ADDENDUM NO. 4:

Date: February 13, 2026
 Project: Verbena HS Gym
 DCM# 2025629
 WSM# 25-032

Owner: Chilton County Board of Education
 Architect: Ward Scott Morris Architecture, Inc.

PROJECT: Verbena HS Gym	ENG #2559 ARCH #25-032 DCM #2025629	DATE: February 13, 2026
-----------------------------------	---	-----------------------------------

E101

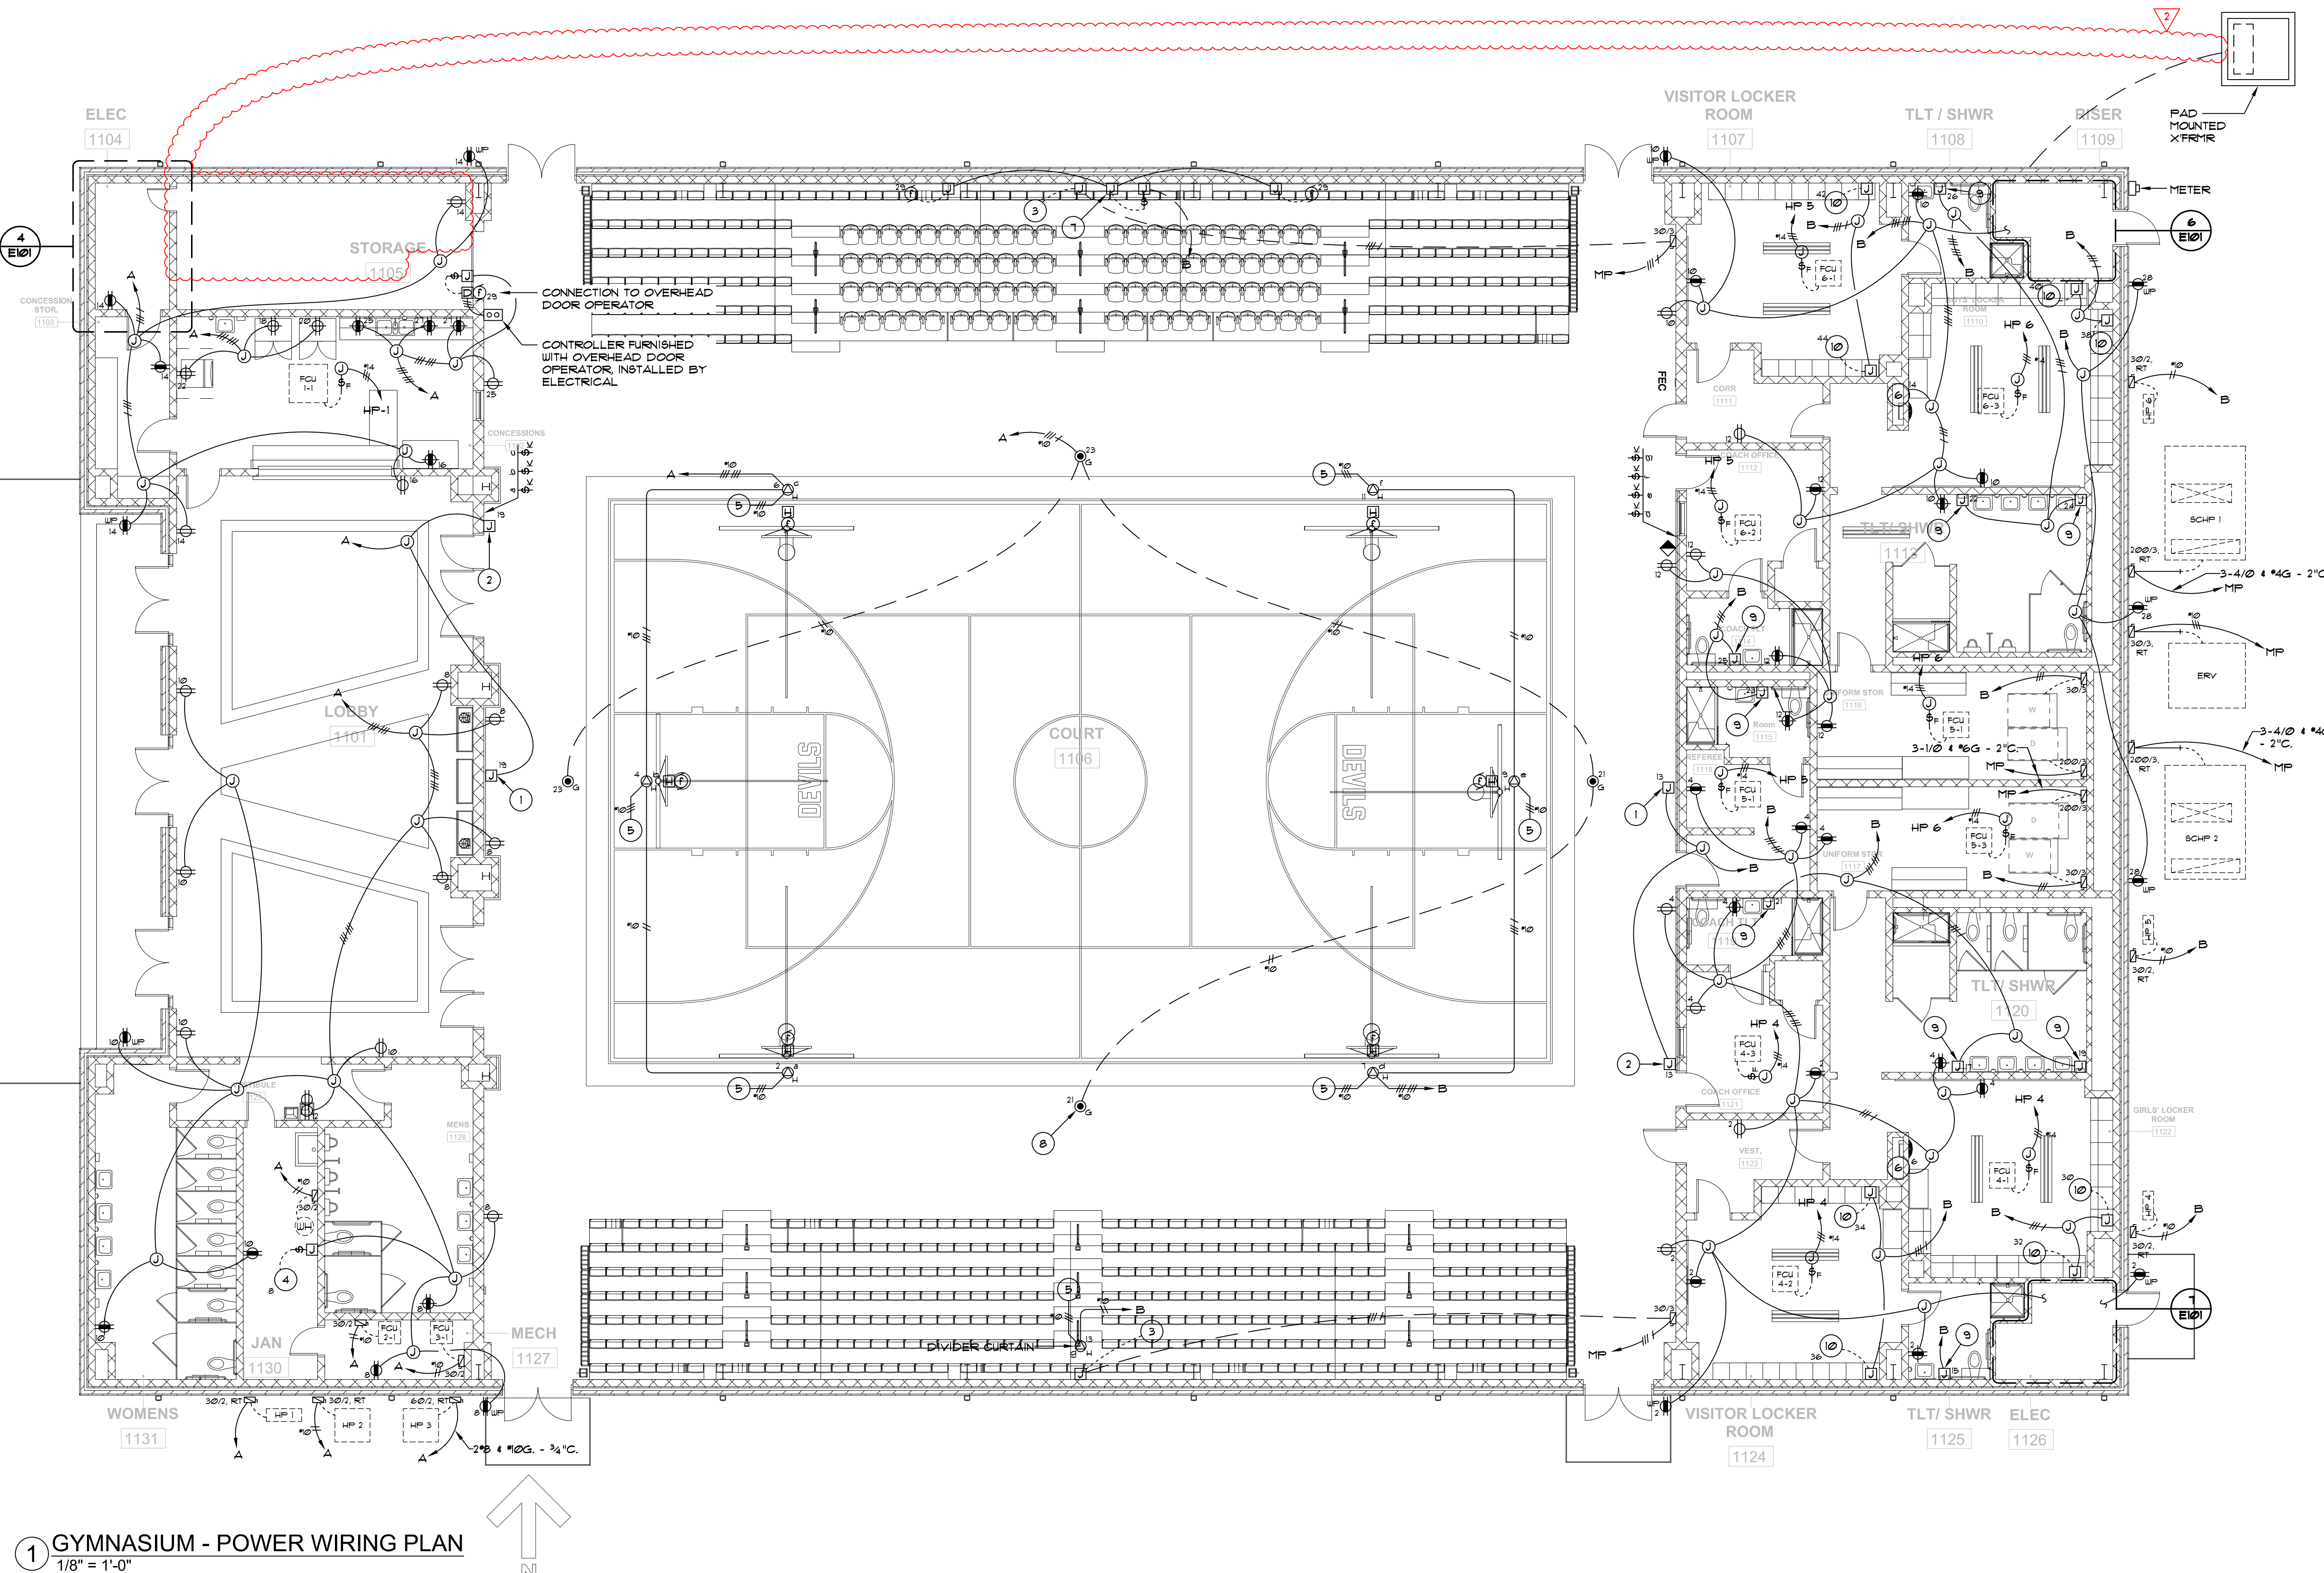
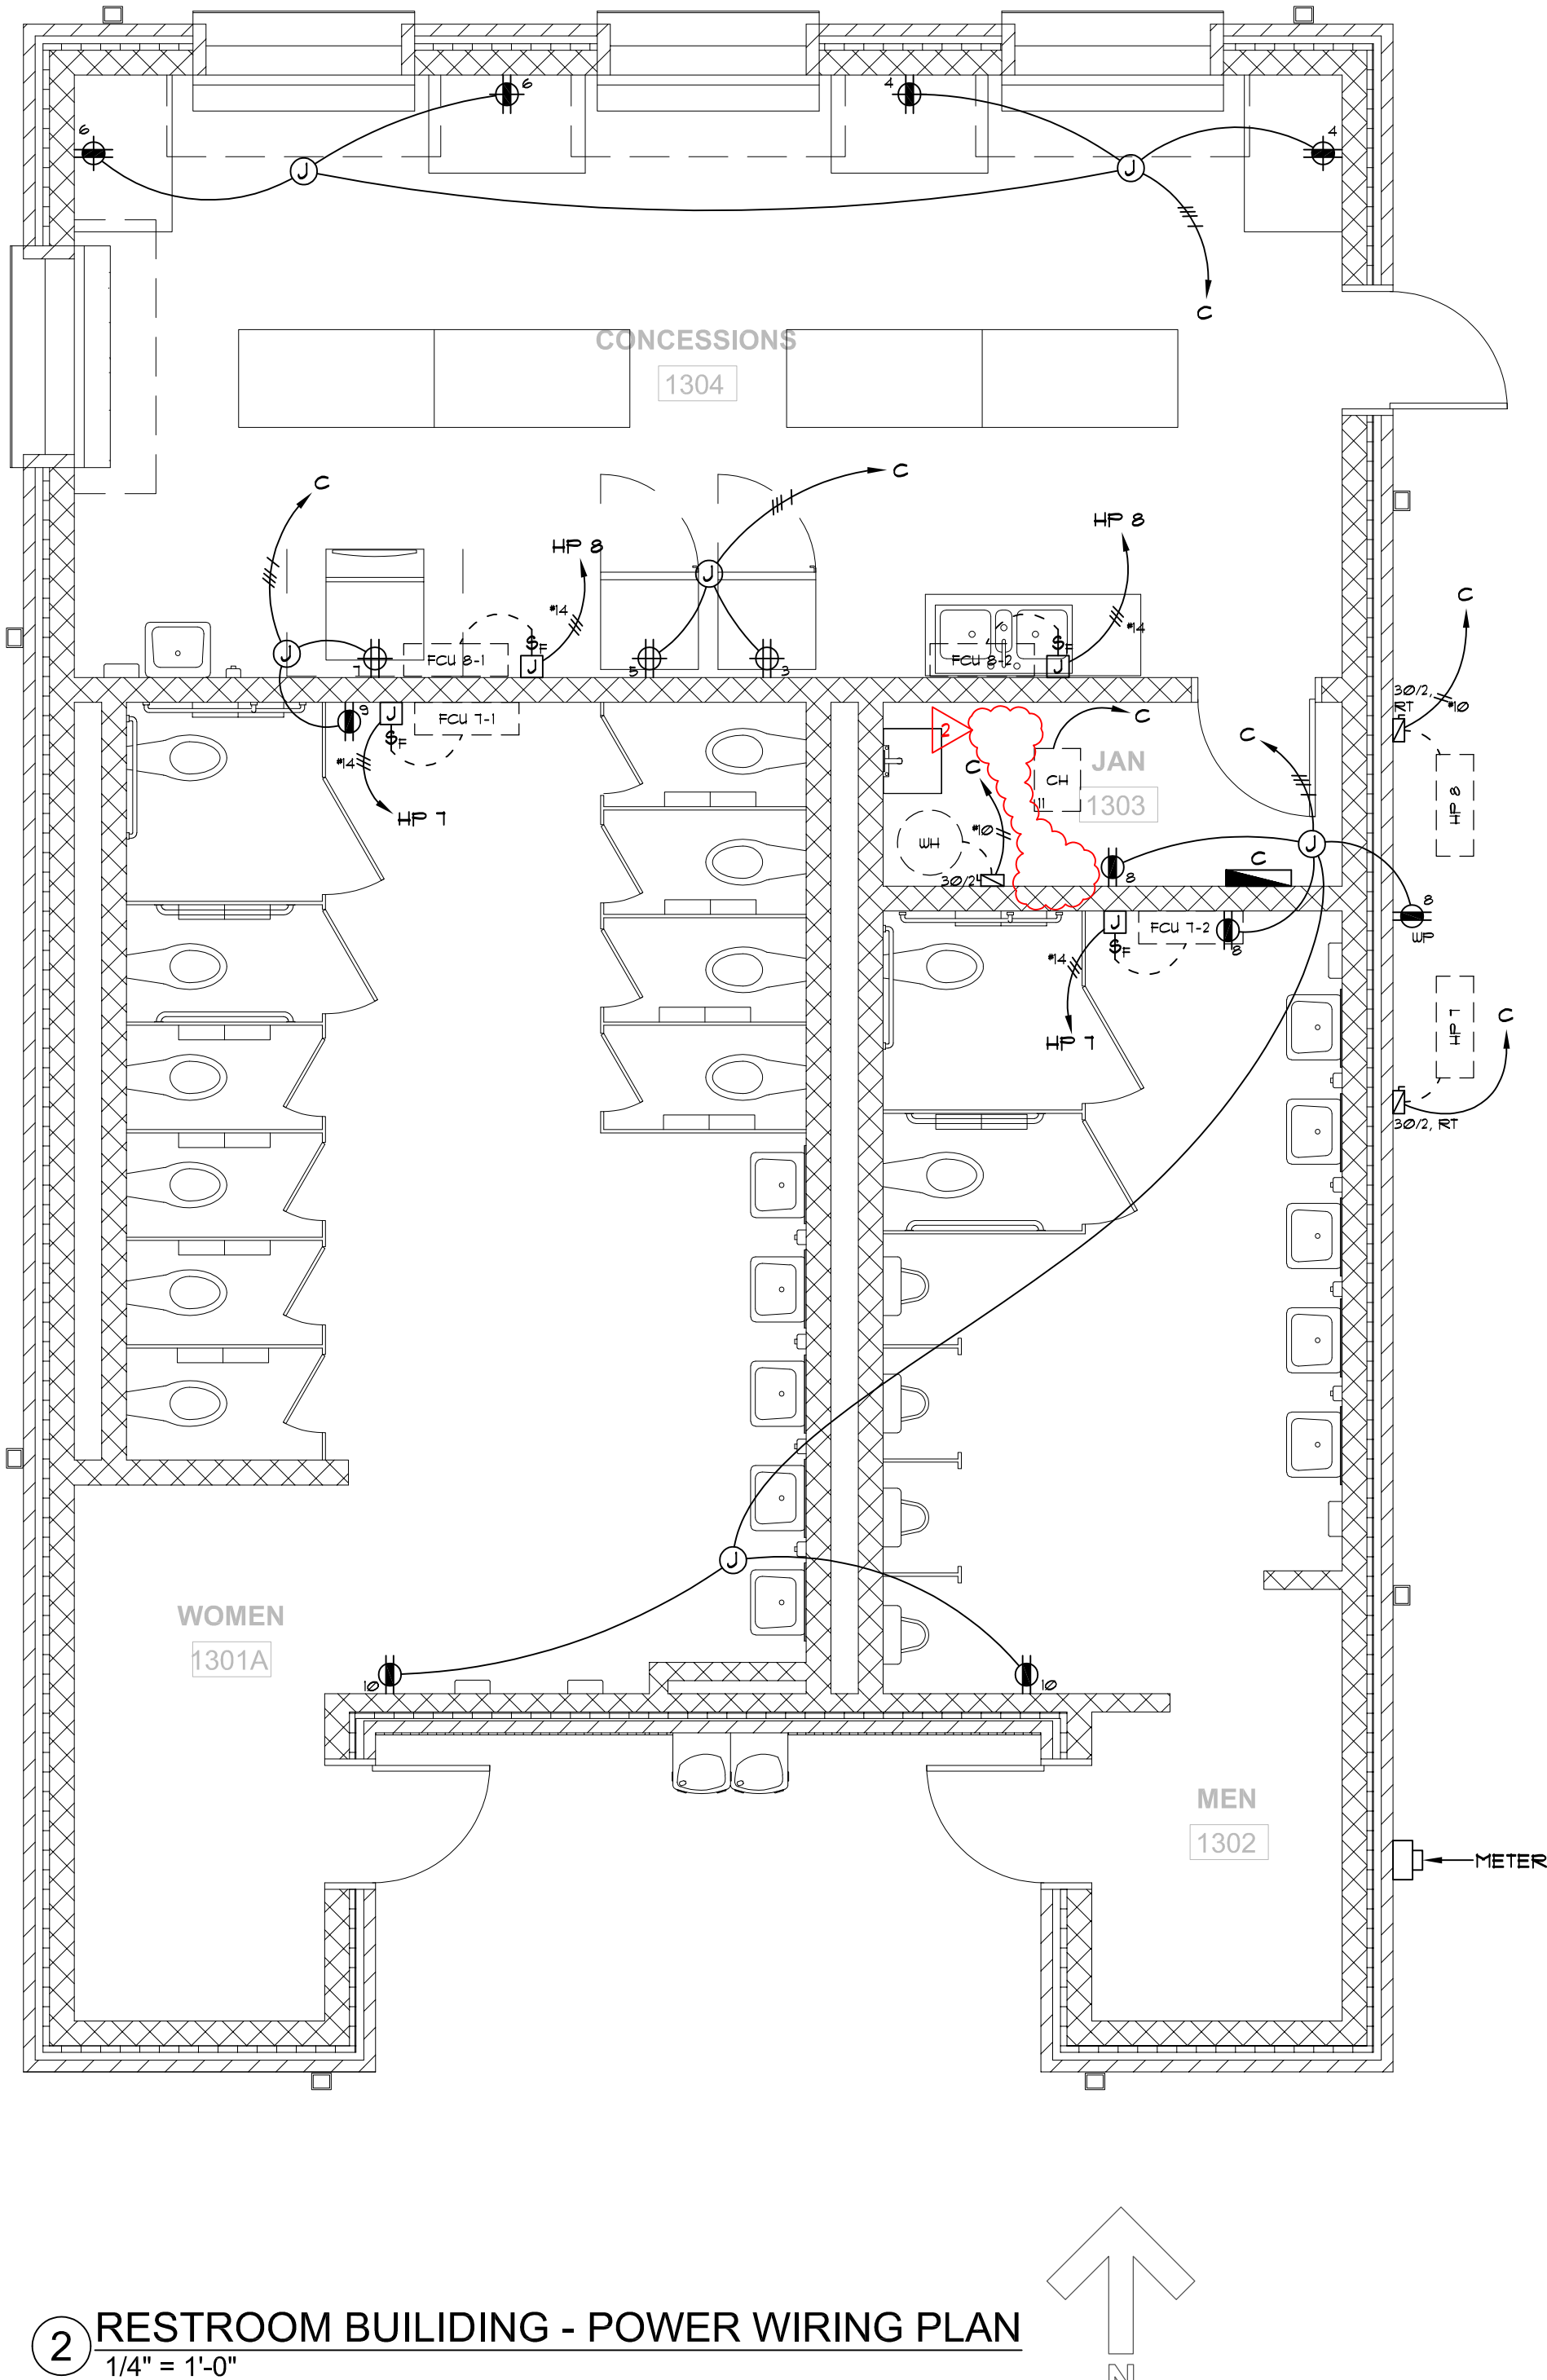
- b. Panel 'B' Schedule: Panel revised to 84 space
3. Sheet E101:
 - a. Gymnasium – Power Wiring Plan:
 - i. Service to fire pump controller removed
 - ii. Storage 1105: CBB 1 relocated to 'Elec 1104'

- b. Electrical Room 1104:
 - i. Fire pump controller removed
 - ii. Pressure booster removed
 - iii. CBB 1 relocated from 'Storage 1105'
 - c. Riser 1190:

- i. Panels 'MP' and 'B' shifted / relocated
 - ii. CBB 2, fire alarm NAC extender panel, and fire alarm audio amplifier relocated to 'Elec 1126'
 - d. Electrical Room 1126: CBB 2, fire alarm NAC extender panel, and fire alarm audio amplifier relocated from Riser 1190

- e. Restroom Building – Power Wiring Plan, Jan 1303: Connection to circulator pump removed
4. Sheet E201, Gymnasium – Lighting Plan:
 - a. Elec 1104: 'S4' luminaire removed
